# APPLICATION

SEWAGE DISPOSAL TESTING

A 1-3406

PLAN OF SURVEY  
 FOR  
 WILTON M. KIEFER  
 FOURTH ELECTION DISTRICT OF HOWARD  
 COUNTY, MARYLAND  
 SCALE: 1 IN. = 100 FT. JANUARY

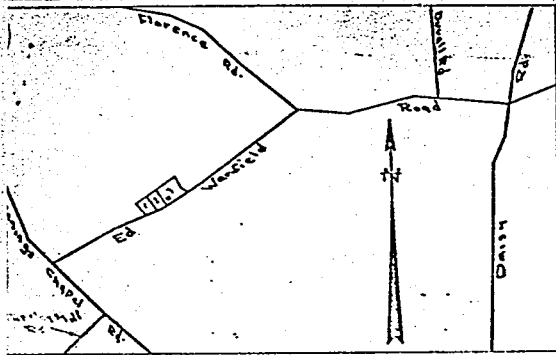
Dry Well - <sup>3 bedrooms</sup> dig pit 16 ft sq. - set black top for 12 ft diameter & fill rest of pit with gravel. Dry Well to be 17 ft deep below inlet pipe. Inlet pipe to be 3 ft below original grade.

Dry Well - 4 bedrooms - Same as for 3 bedrooms but 9 1/2 ft deep below inlet pipe. Please Dry Well about 69 ft from rear lot line and about 39 ft from north side of driveway when facing from E. Warfield Rd.

✓ APPROVED BY Samuel M. Williams, Jr. FOR Dry Well DATE 2-20-68  
(KIND OF SYSTEM)
